## Architectural Statement of Response to the ABP Opinion

**Project:** Proposed Strategic Housing development (alterations to phase 1 residential and proposed phase 2 residential development) at the Frascati Centre, Frascati Road (N31), Blackrock, Co. Dublin (formerly known as Frascati Shopping Centre)

**Date:** 26<sup>th</sup> August 2020

SECTION D-D REVISED FOR PLANNING PROPOSAL

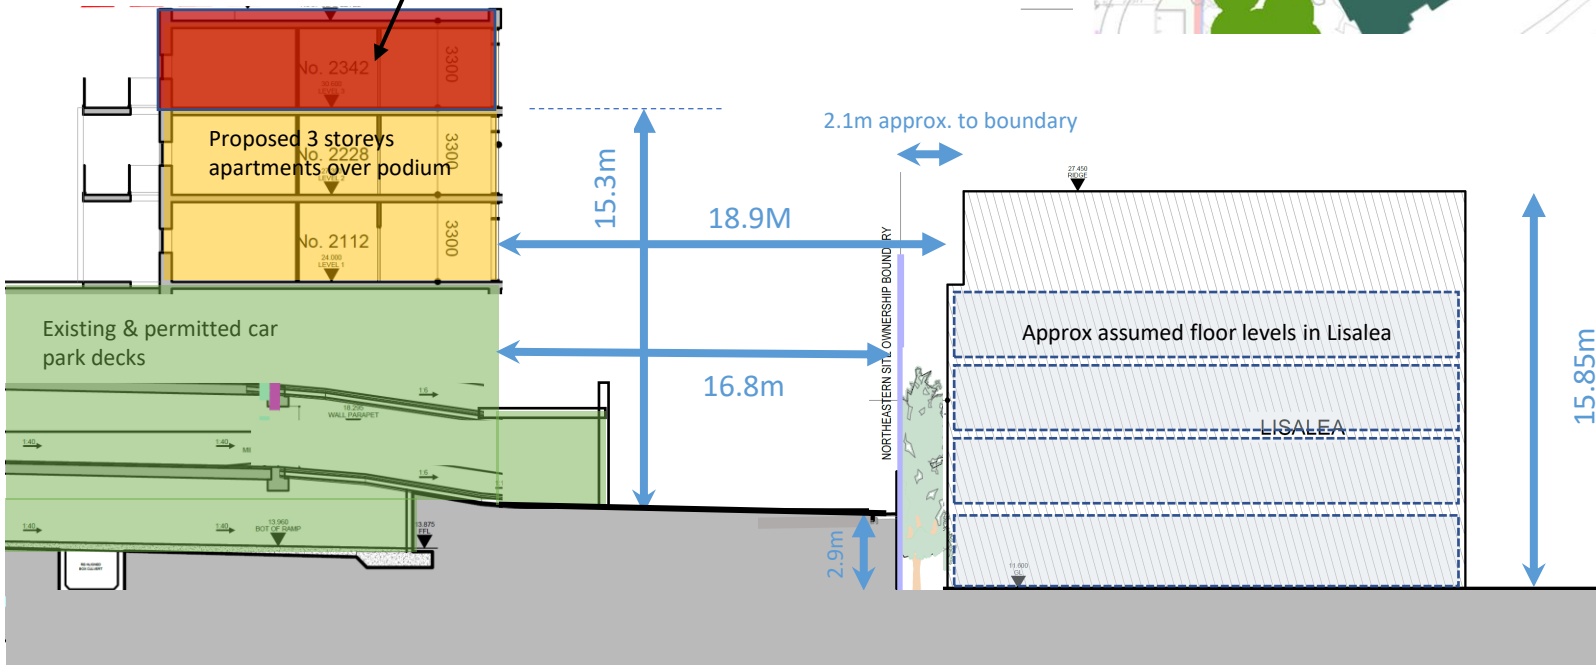
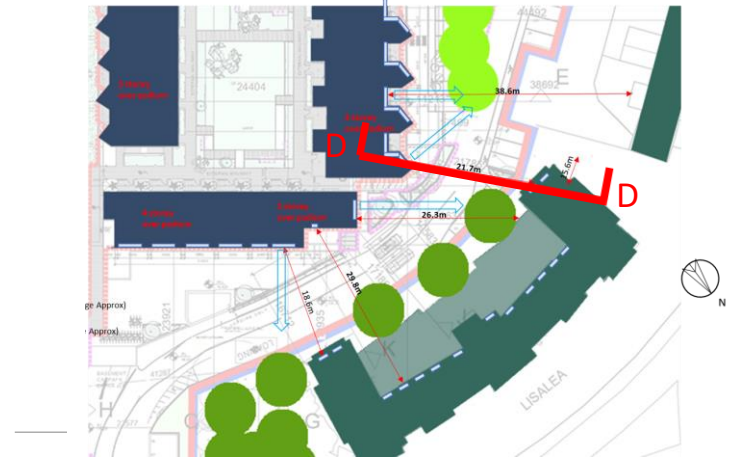
#### SECTION D-D PREVIOUS PRE PLANNING PROPOSAL

OMISSION OF TOP FLOOR APARTMENT AT CORNER TO REDUCE IMPACT ON ADJOINING LISALEA APARTMENTS

PREVIOUS PRE-PLANNING THIRD FLOOR PLAN

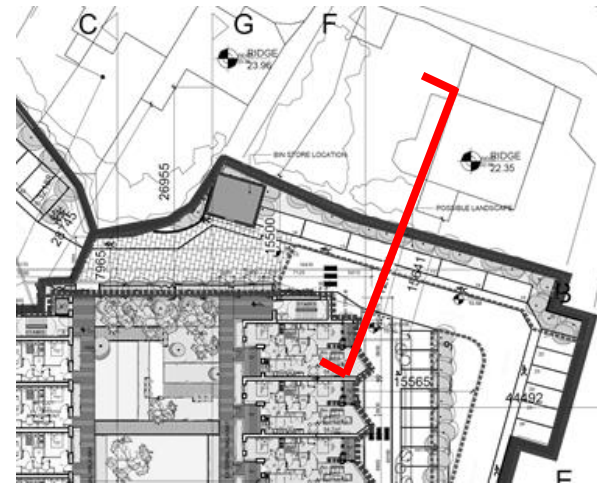
It was noted that the 'saw tooth' profile of the proposed top floor apartment as shown in the pre-planning scheme which gives good south west orientation to the living areas also presented a potential overlooking issue.

MODIFIED LAYOUT OF END APARTMENT HERE ON THIRD FLOOR TO AVOID OVERLOOKING OF SINGLE STOREY HOUSE ON FRASCATI PARK

### SECTION F-F PREVIOUS PROPOSAL

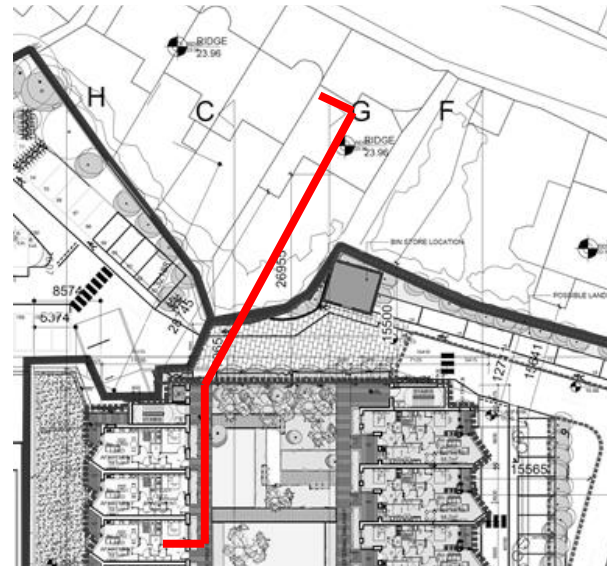
It is proposed that the phase 2 apartment building will step back at the south east corner from the previously proposed pre-planning scheme. This results in the omission of 2no. Apartments from the previous proposals.

141 PROPOSED SECTION BB WITHOUT PLANTS (BLOCK D&F SOUTH WEST ELEVATION)  
Scale: 1:100 @ A1

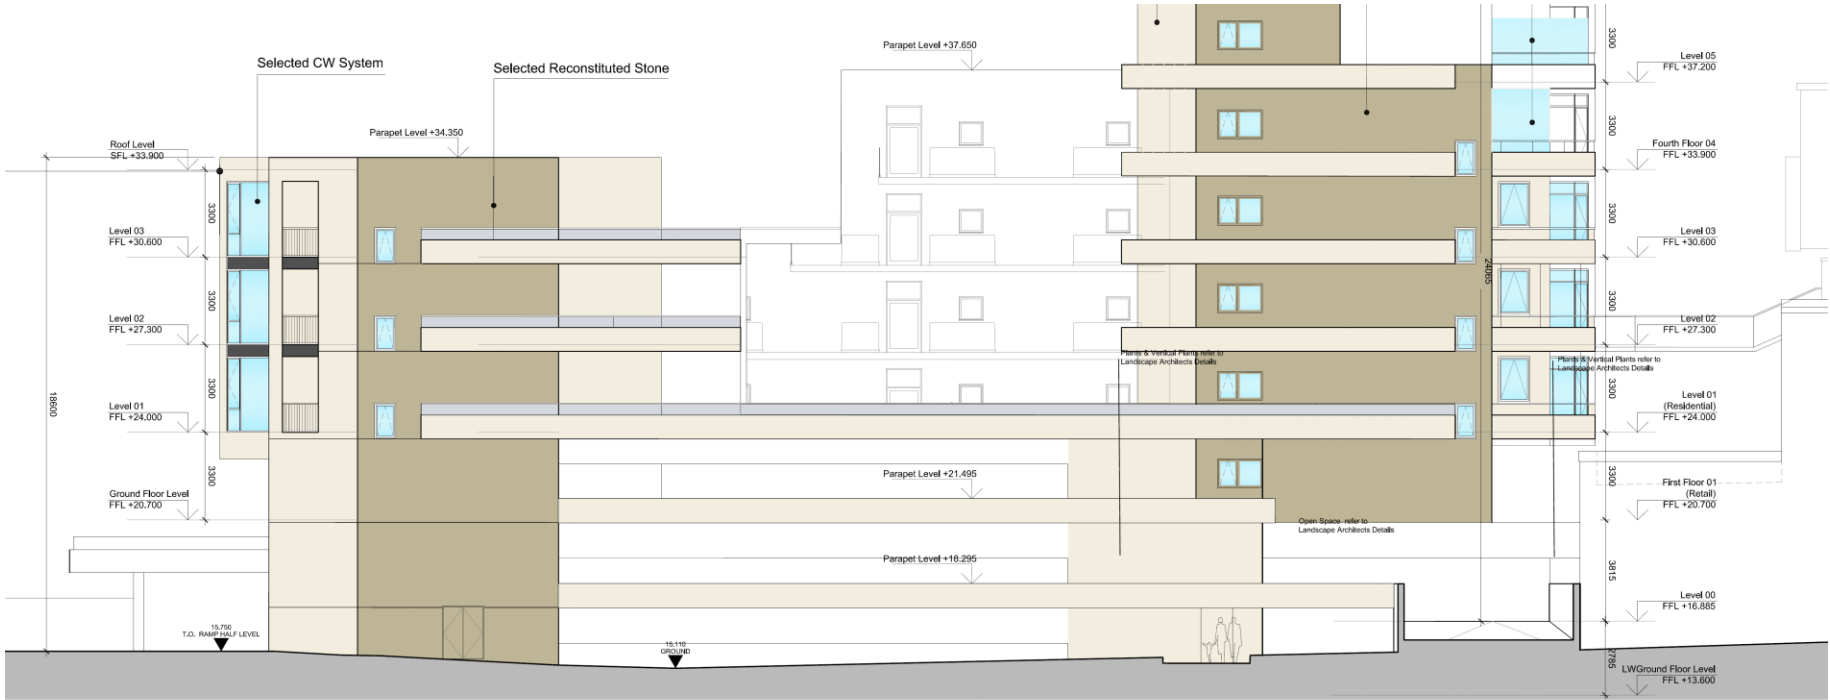
*Drawings should illustrate the proposed buildings without any obstruction from landscaping or planting elements. Separate drawings detailing the inclusion of green walls should also be provided.*

Drawings illustrating the proposed buildings without any obstruction from landscaping or planting elements below as included in the planning application submission.
